STATE OF NORTH CAROLINA
DEPARTMENT OF TRANSPORTATION

Subject: Permit Modification Request for **Nationwide Permit 23 and Tar-Pamlico Riparian Buffer Authorization Request** for the proposed replacement of Bridge Nos. 127 over the Tar River Overflow and 129 over the Tar River on SR 1565 in Pitt County. TIP No. B-3684; Federal Aid Project No. BRSTP-1565(4); State Project No. 8.2221101. Debit \$240 from WBS No. 33225.1.1

Pitt County
PROJECT: B-3684 (Bridge #129)

PROJECT REFERENCE NO. B-3684	SHEET NO. 6
NW SHEET NO.	
ROADWAY DESIGN ENGINEER	HYDRAULICS ENGINEER
Permit Drawing Sheet <u>10</u> of <u>35</u>

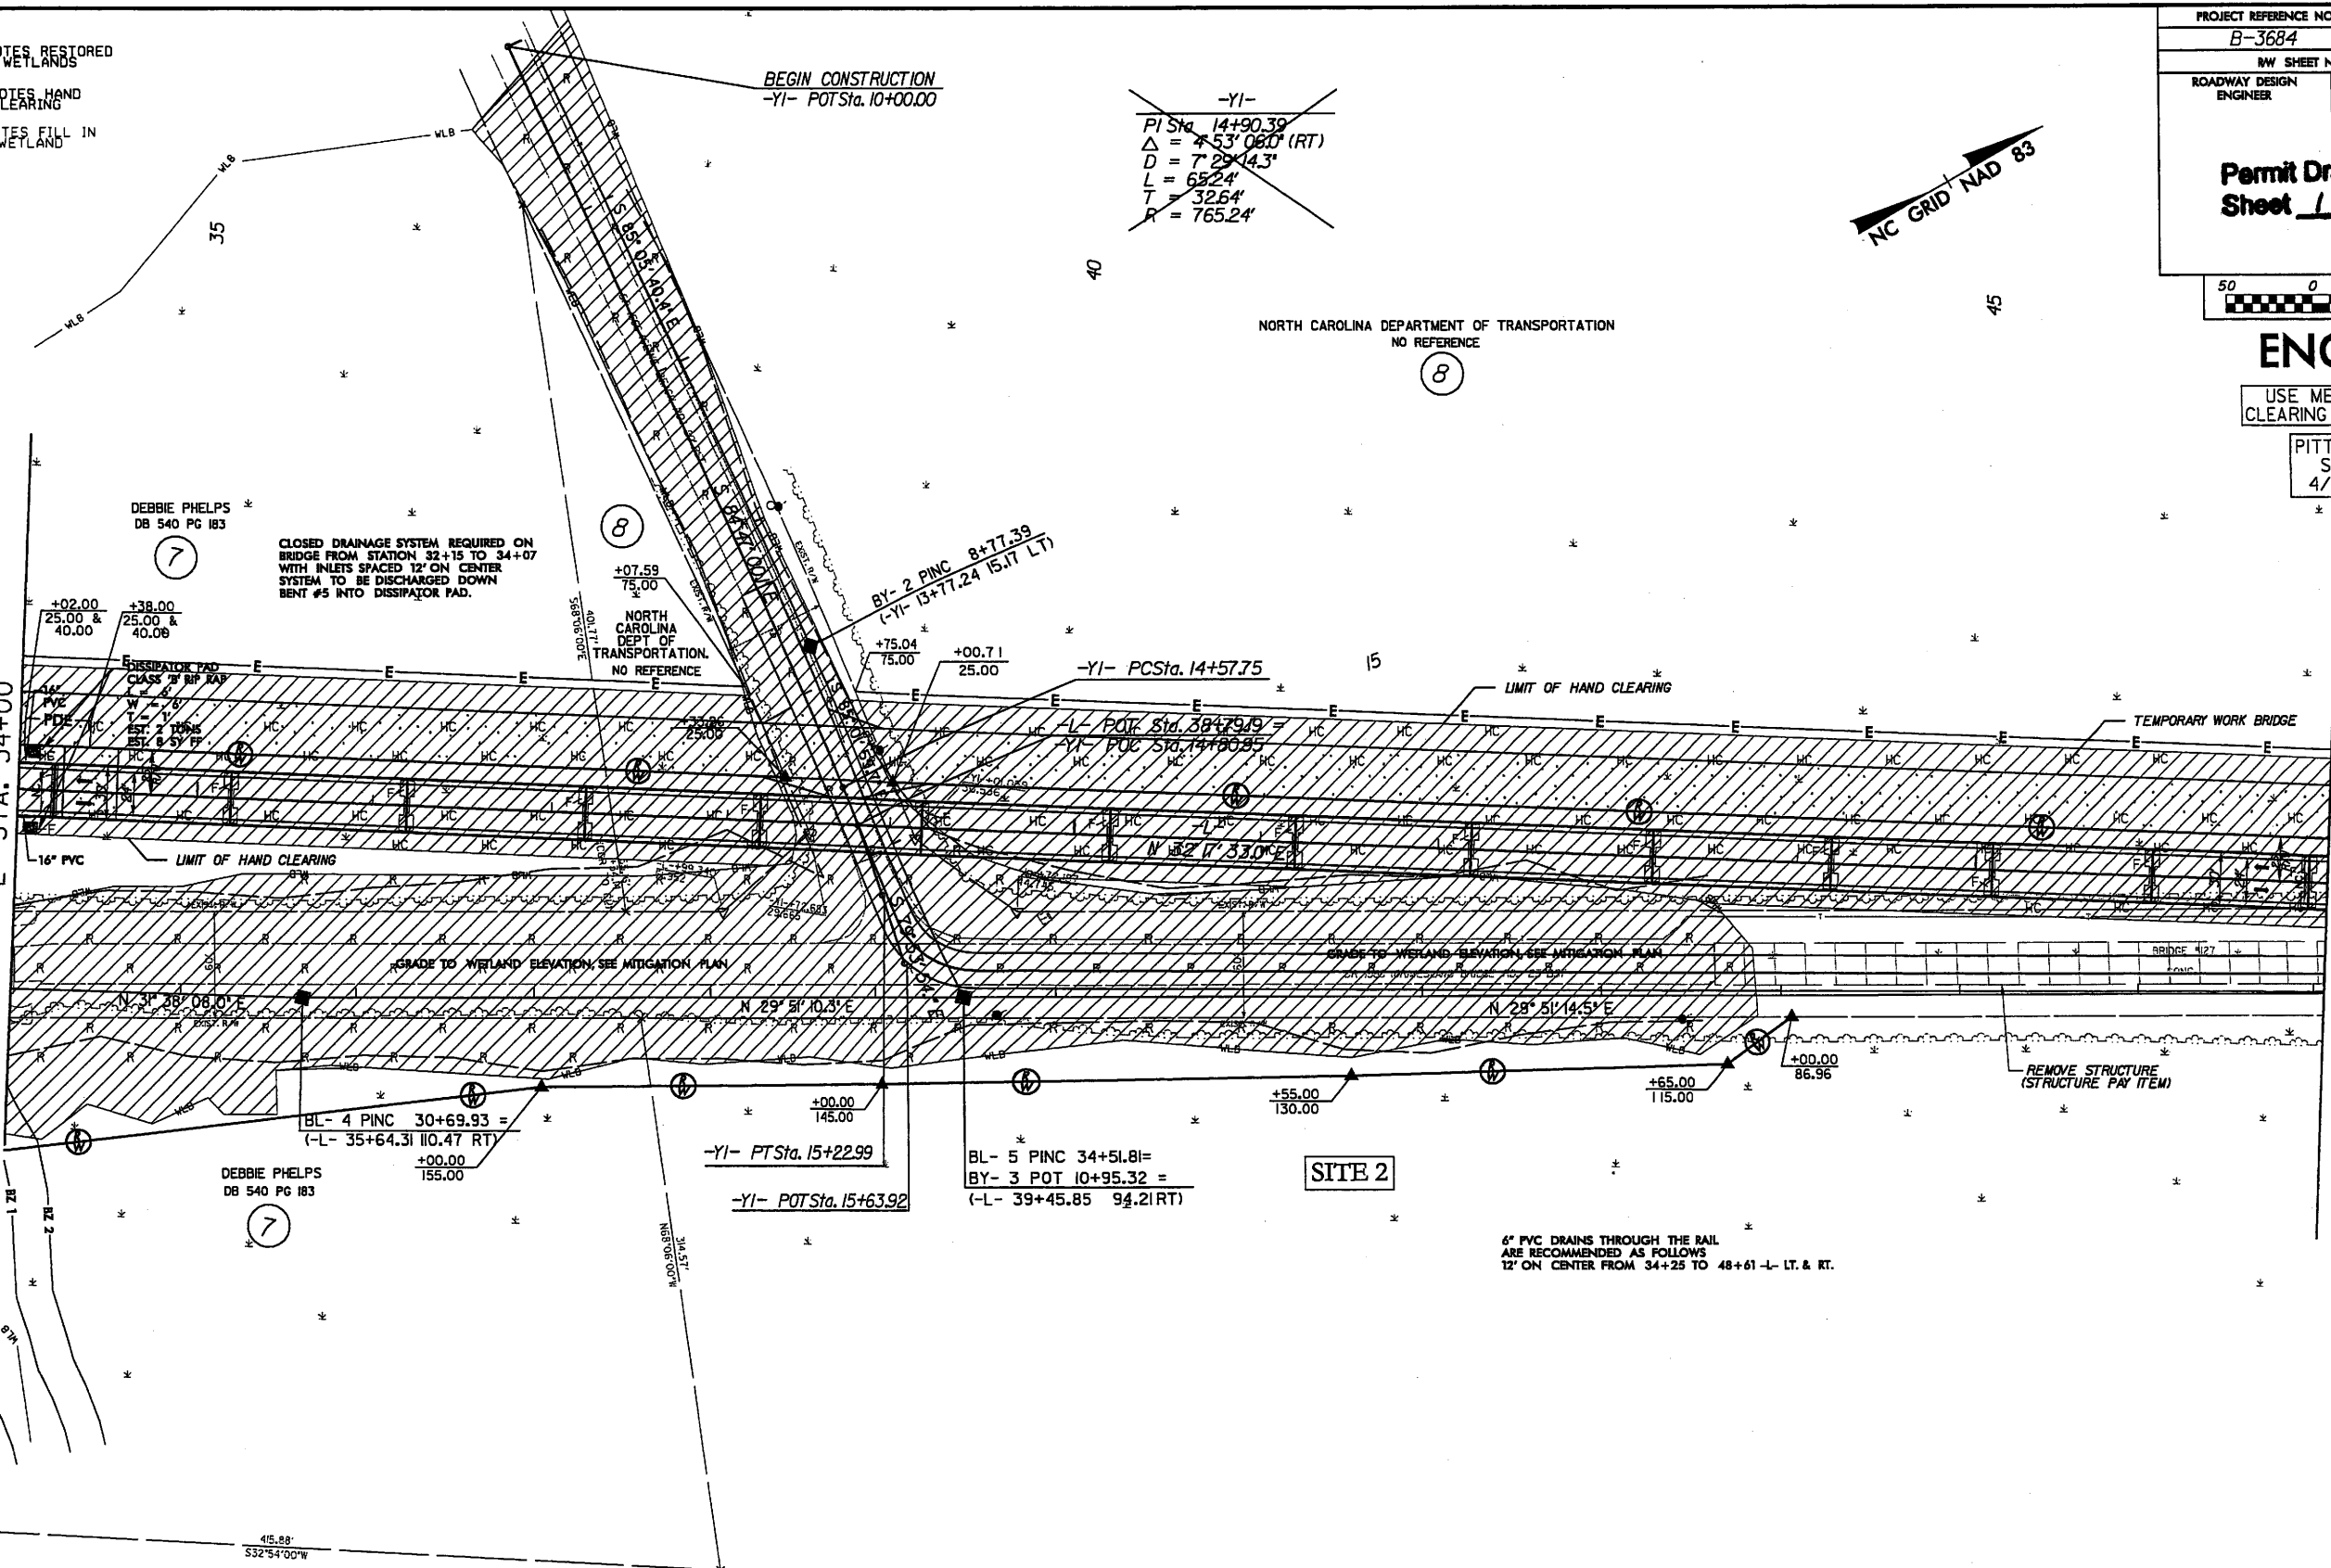
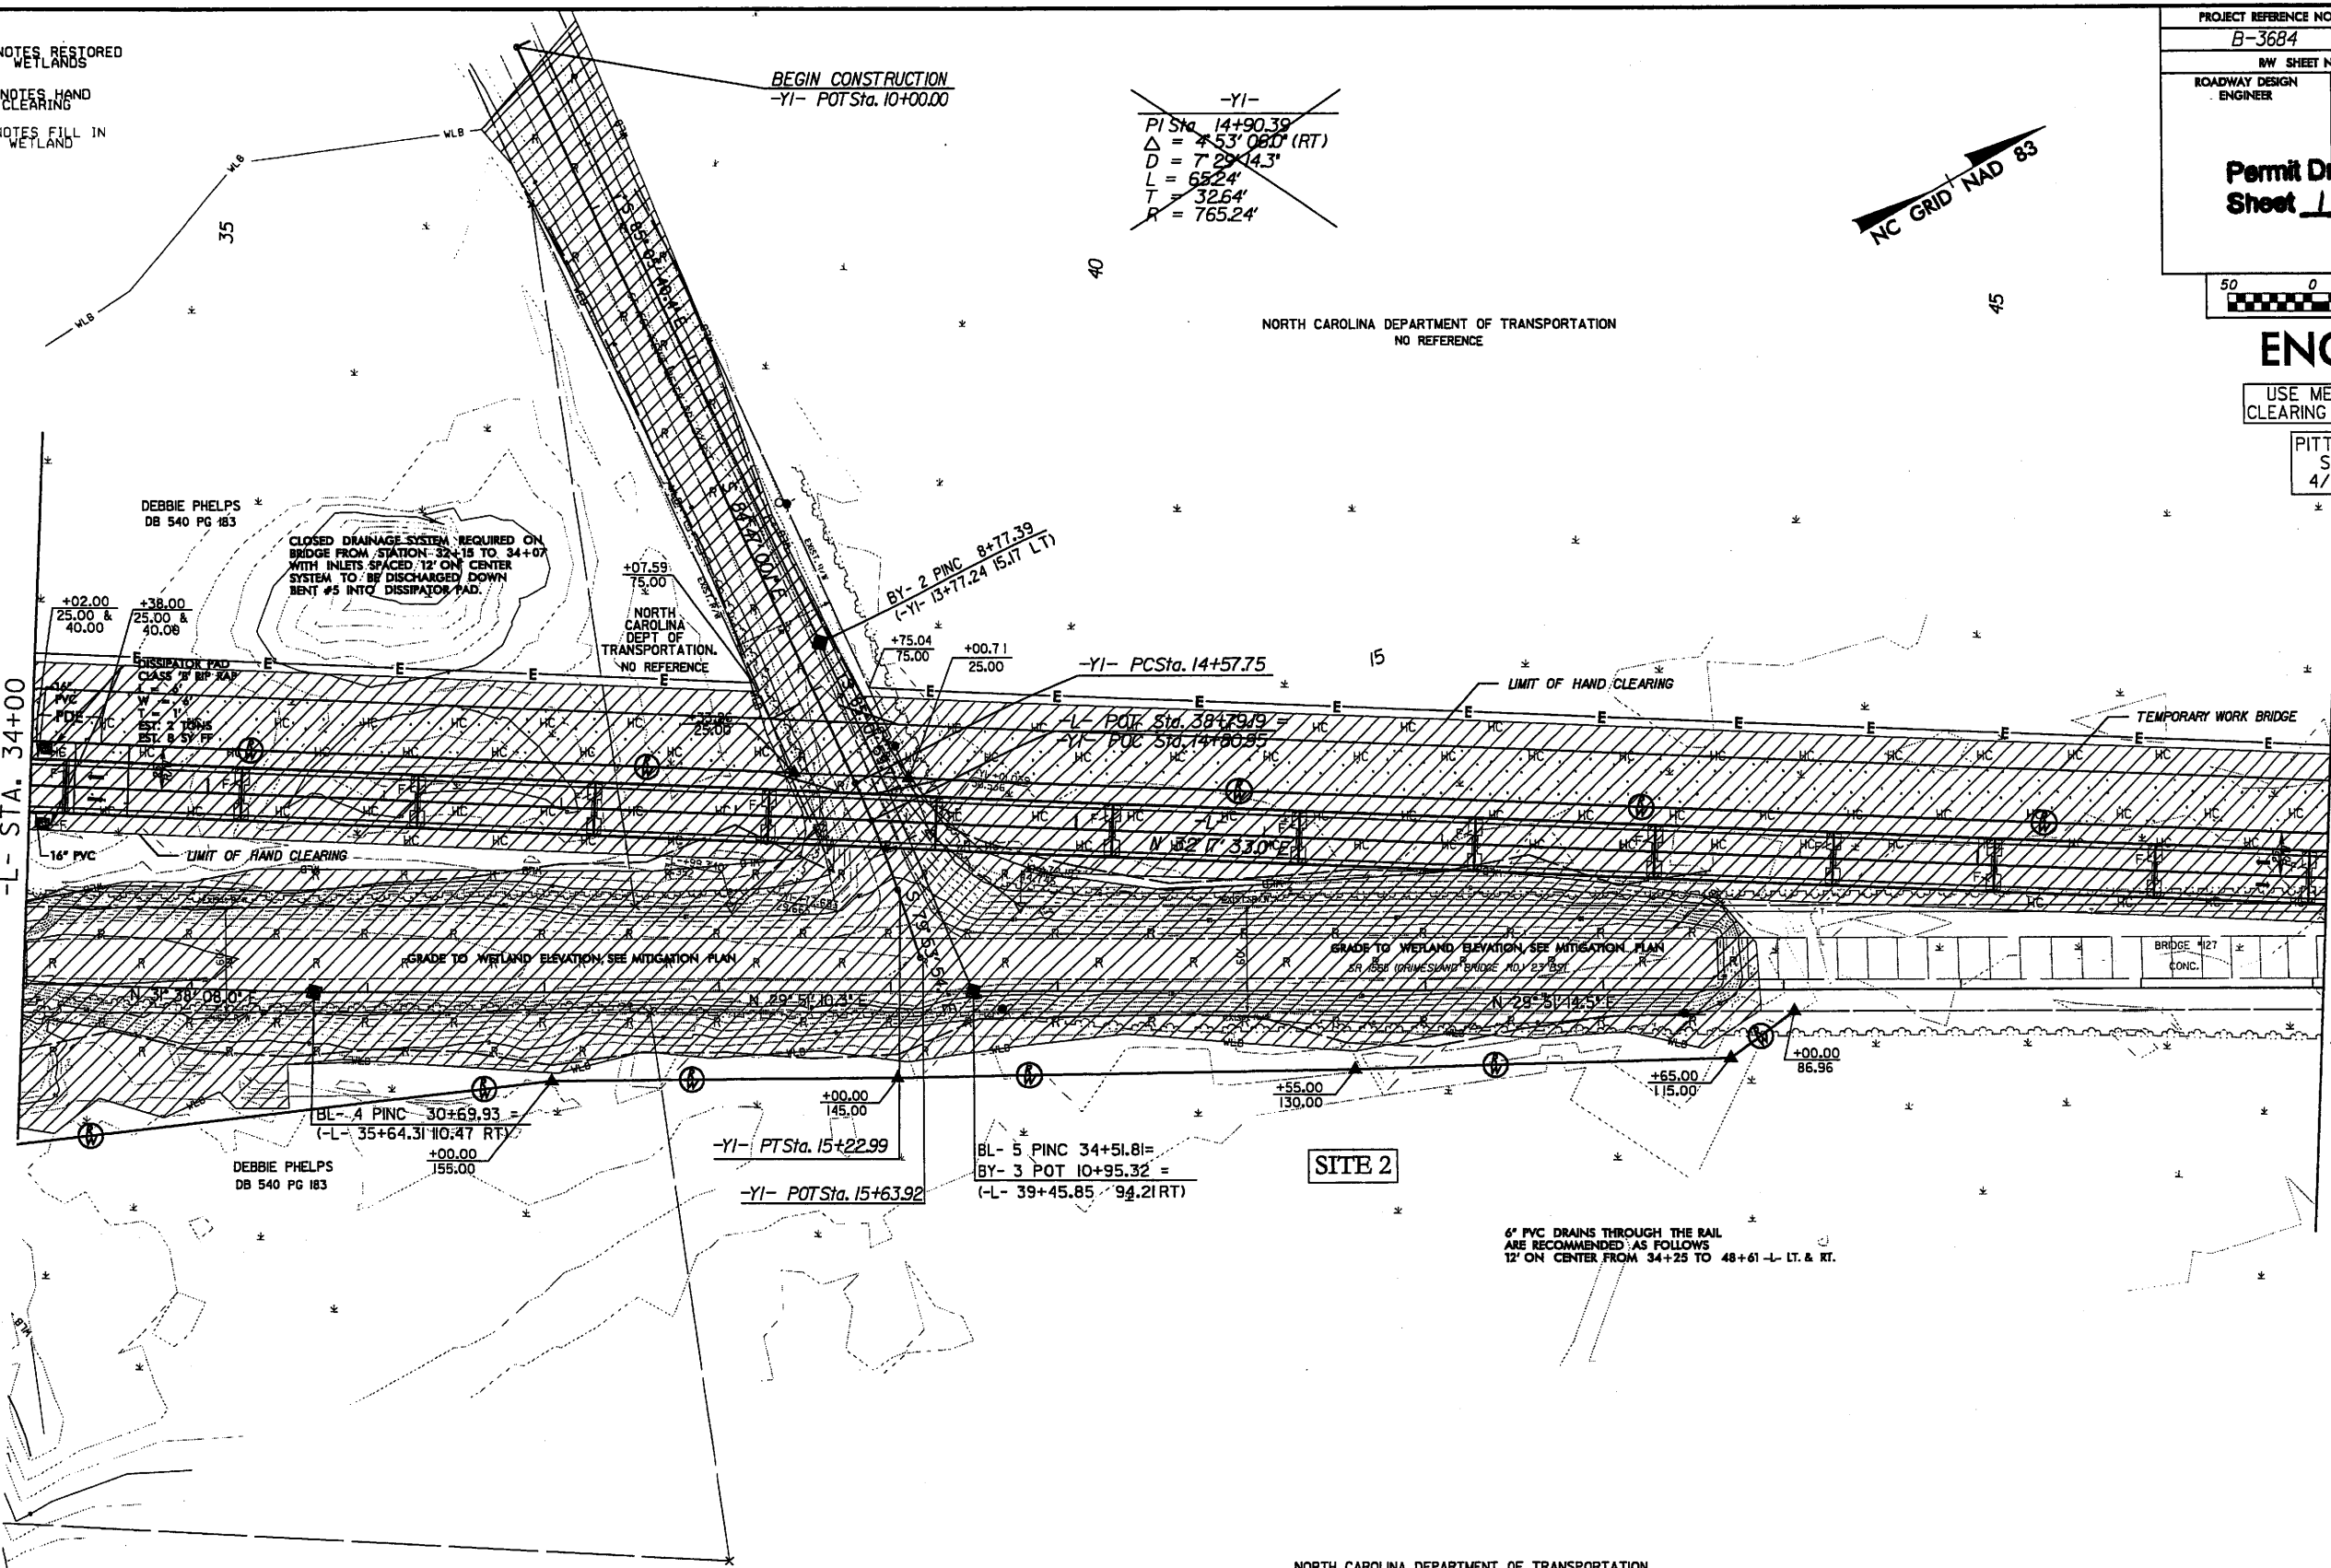
REVISIONS
12-07-07 R/W REVISION ADJUSTED EASEMENT TO PARCEL NO.7 & NO.8 DUE TO PERMIT DRAWING IN THE GRIMESLAND MITIGATION SITE.

REVISIONS
12-07-07 R/W REVISION ADJUSTED EASEMENT TO PARCEL NO.7 & NO.8 DUE TO PERMIT DRAWING IN THE GRIMESLAND MITIGATION SITE.
